AGENDA
Regular Hybrid Meeting
Town of Granby
Inland Wetlands and Watercourses Commission
Wednesday, July 9, 2025, at 7:00 pm
Town Hall Meeting Room

Site Plan Review for Inland Wetlands Application

Plan: "Preliminary Site Plan Application Plans for AutoZone Granby, 8 E Granby Road, Granby, CT 06035, Date: 5/13/2025, Sheets C-0.0 through C-6.2, Kimley-Horn & Associates, Inc, Revised 7/01/25."

This letter is being submitted by Kimley-Horn & Associates, Inc. on behalf of AutoZone, Inc. ("Applicant") in response to the department review letters listed below:

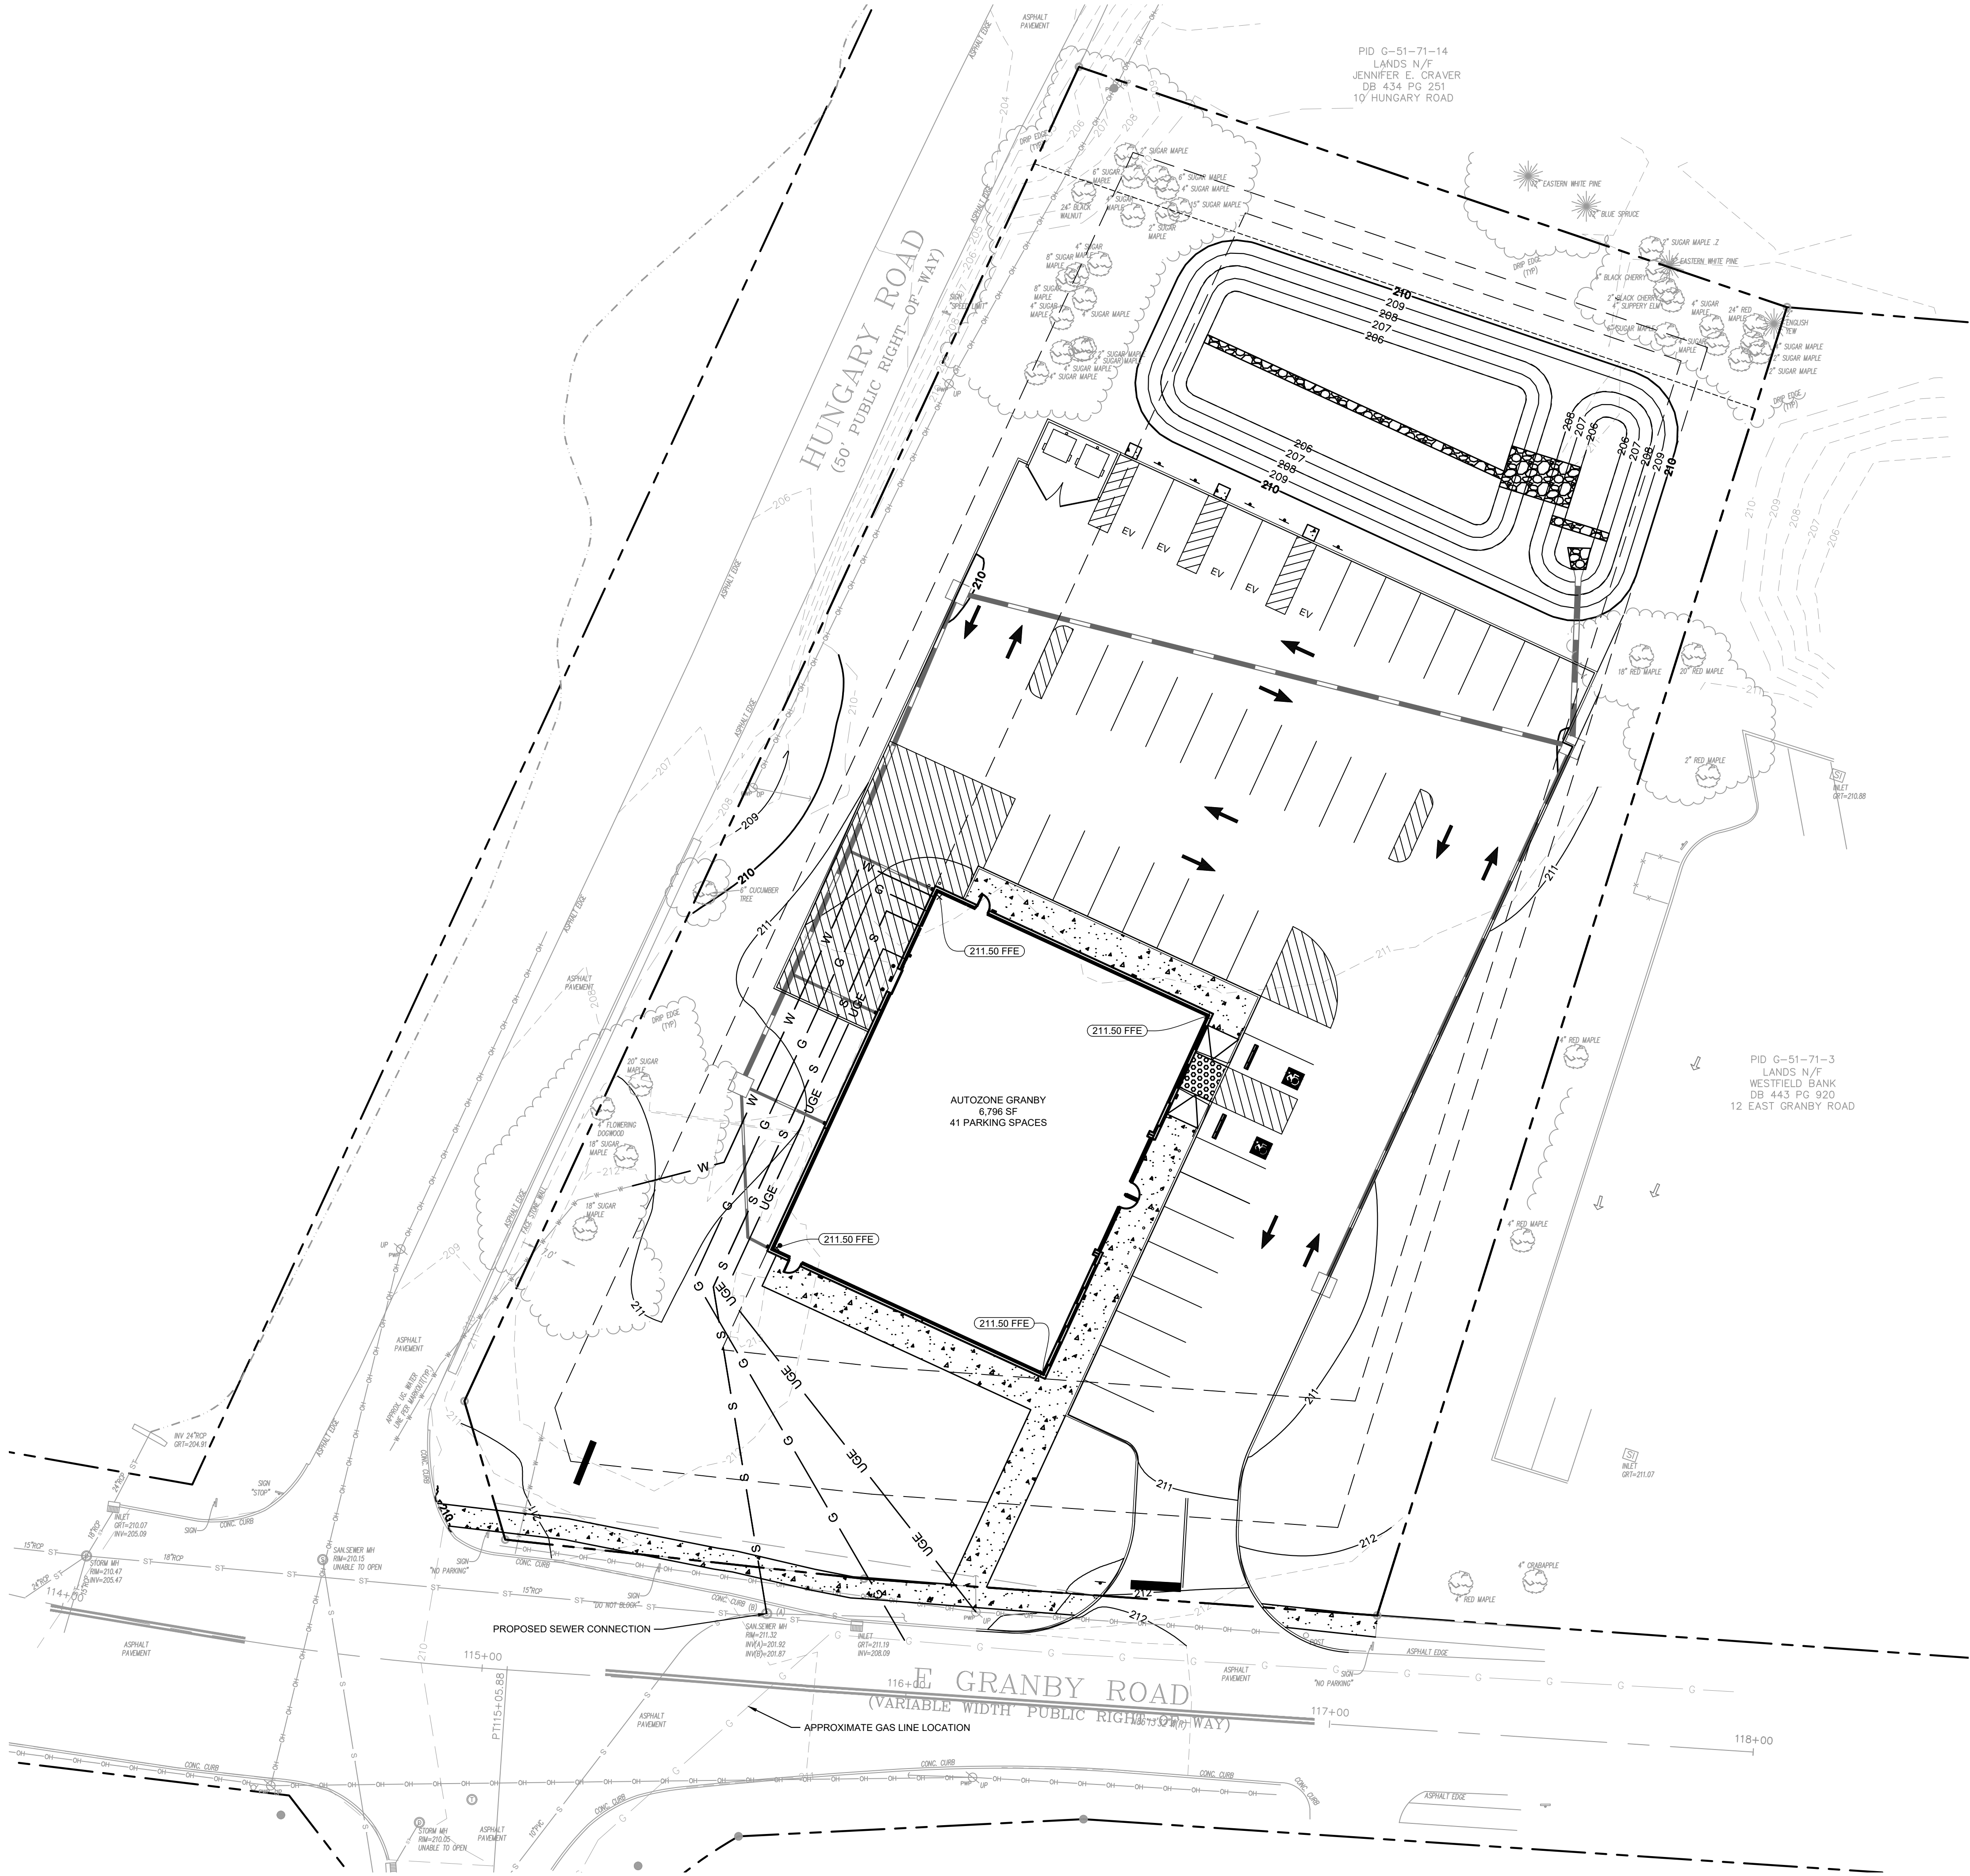
6. Show FFE.

7. Additional information (e.g. inverts, cleanouts, pipe length and slope, etc.) is required for the sanitary sewer connection. This is not needed for the wetlands application but will need to be shown on the site plan application plans.

Response: Sheet C-4.0 has been revised to include the FFE.

Response: Comment Acknowledged. Additional information regarding the sanitary sewer connection will be provided with the site plan application plans.

SHEET NUMBER
C-5.0

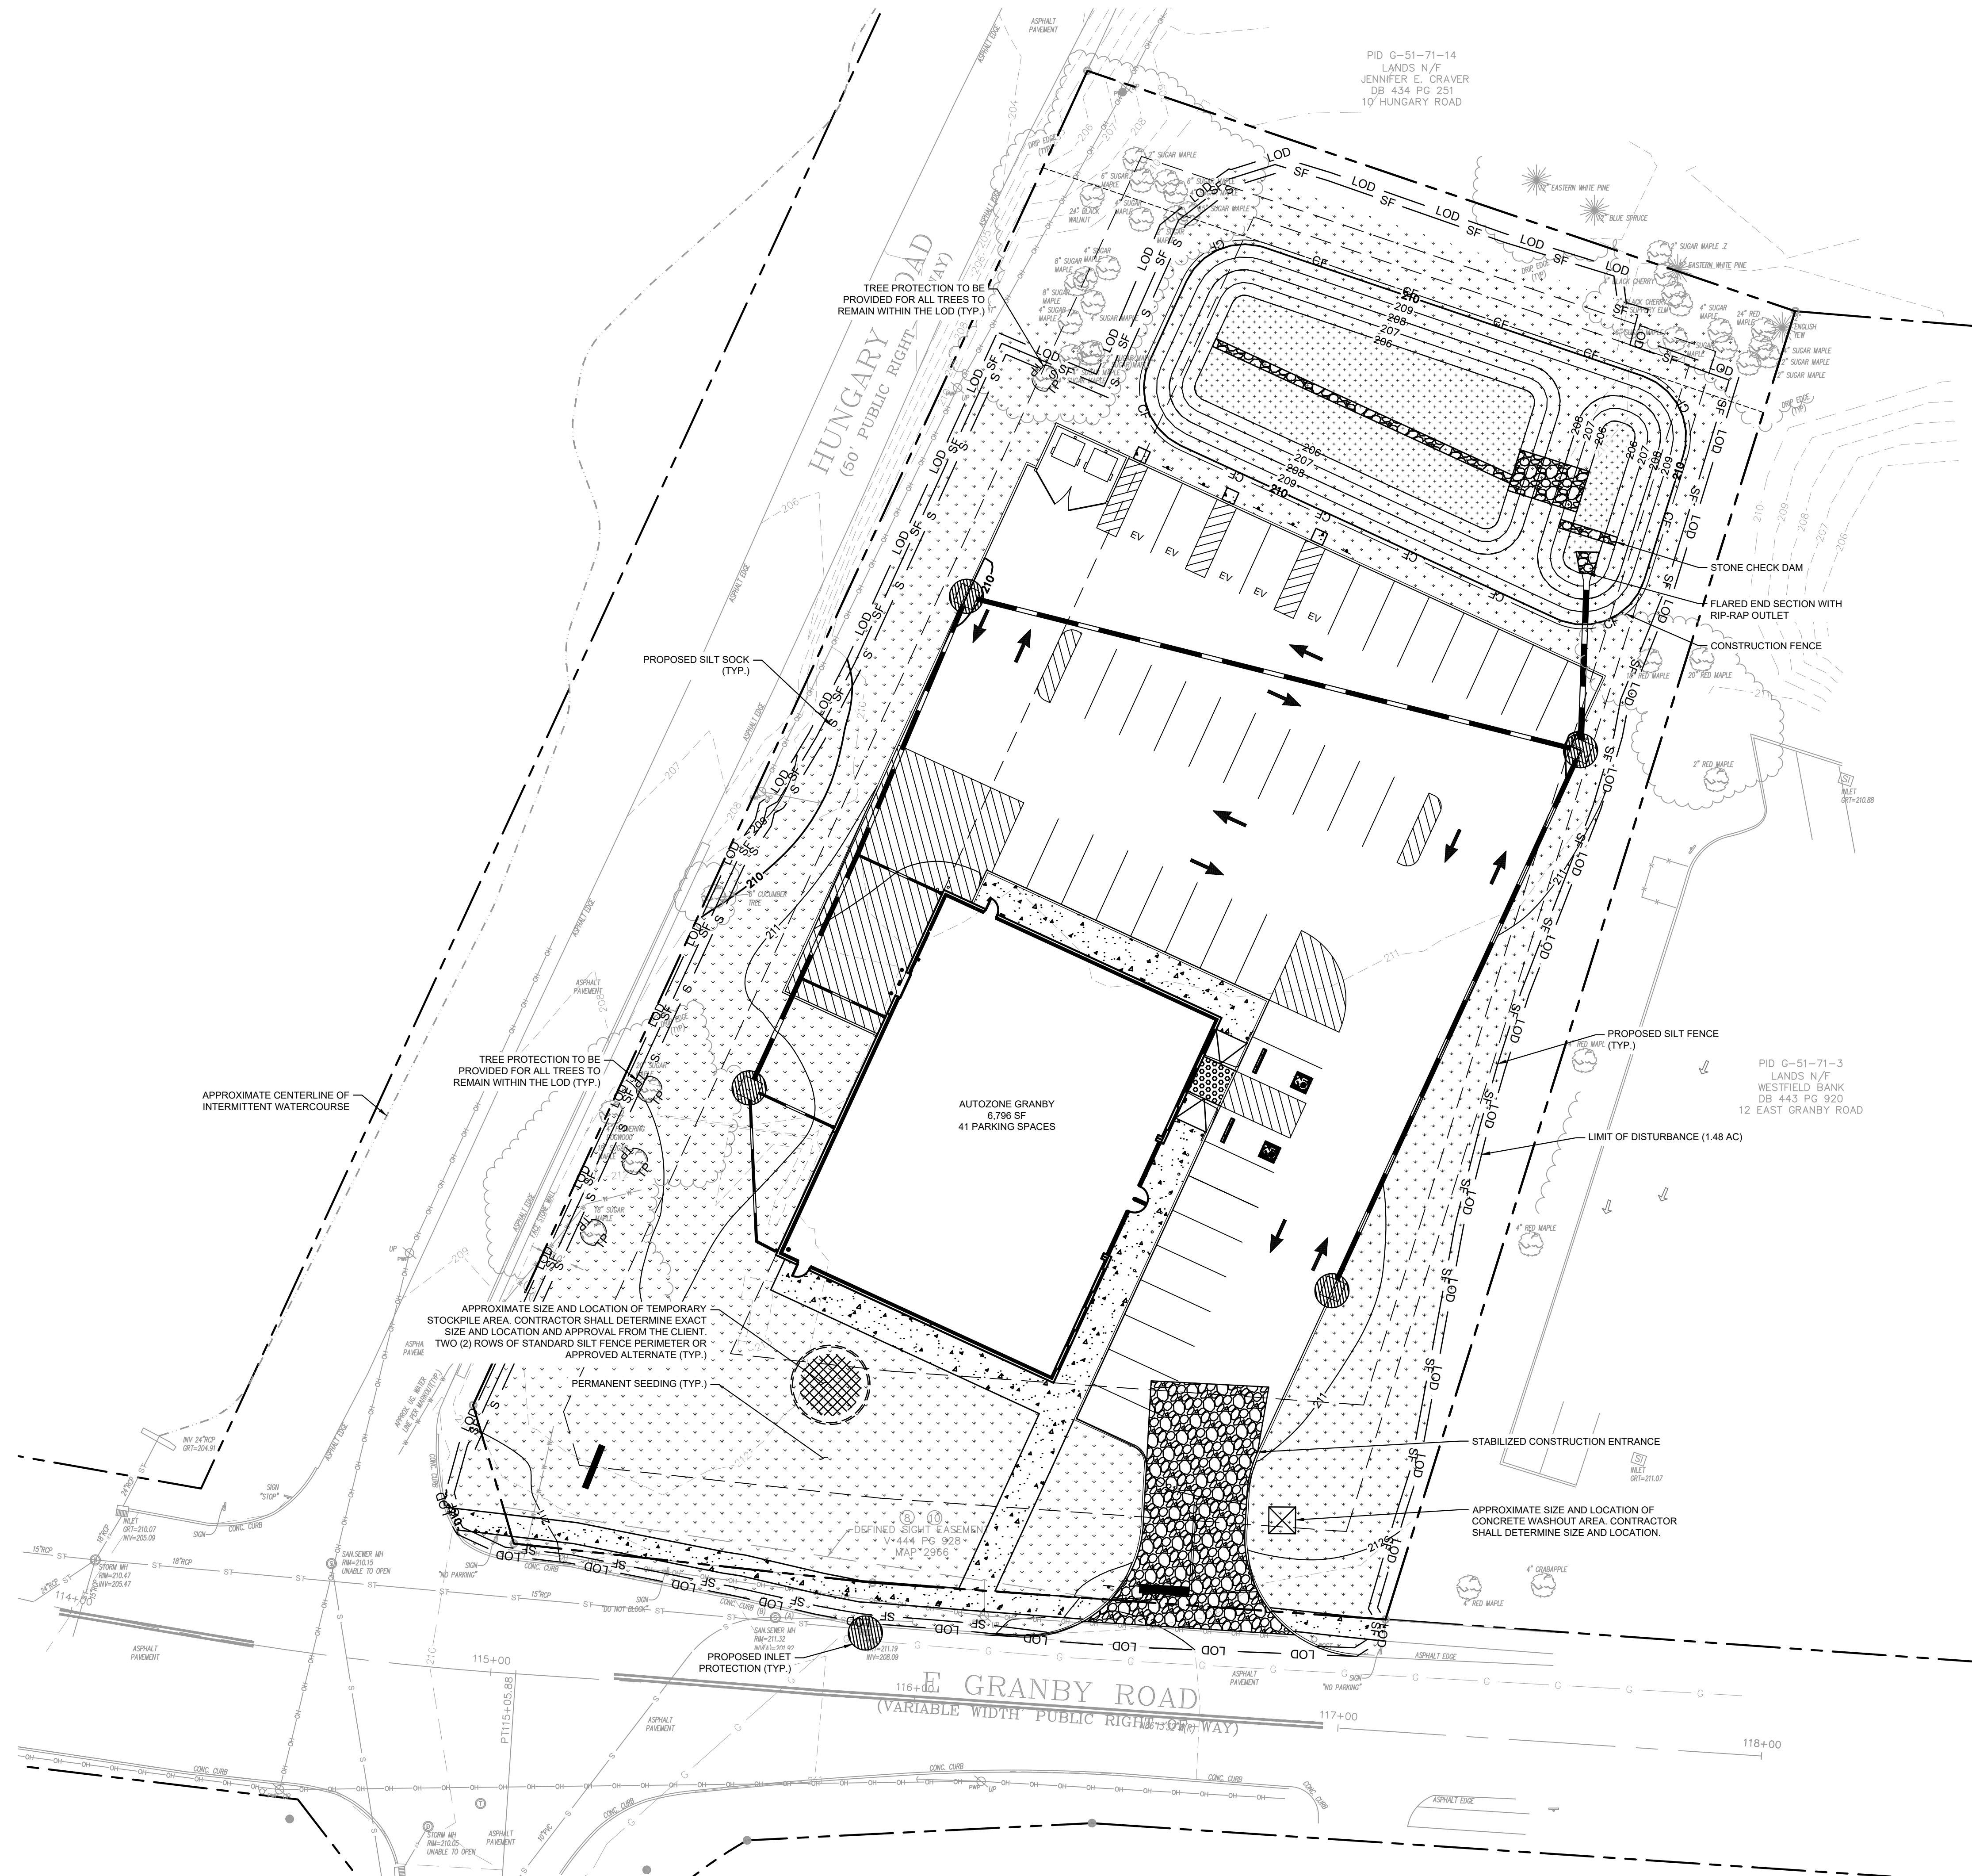
8. Show tree protection where its required.

3. Sheet C-5.0 shows silt fence to be specified as a perimeter erosion control barrier enclosing the entire disturbance area. It is recommended that a more robust perimeter control be located along the westerly property boundary, to aid in protecting the adjacent watercourse, where there is a slope adjacent to Hungary Road.

Response: Sheet C-5.0 has been revised to show tree protection where required.

Response: Sheets C-5.0 and C-5.1 have been revised to include an additional row of silt sock before the silt fence on the western property boundary per discussion with Kate Bednaz on 6/5/2025.
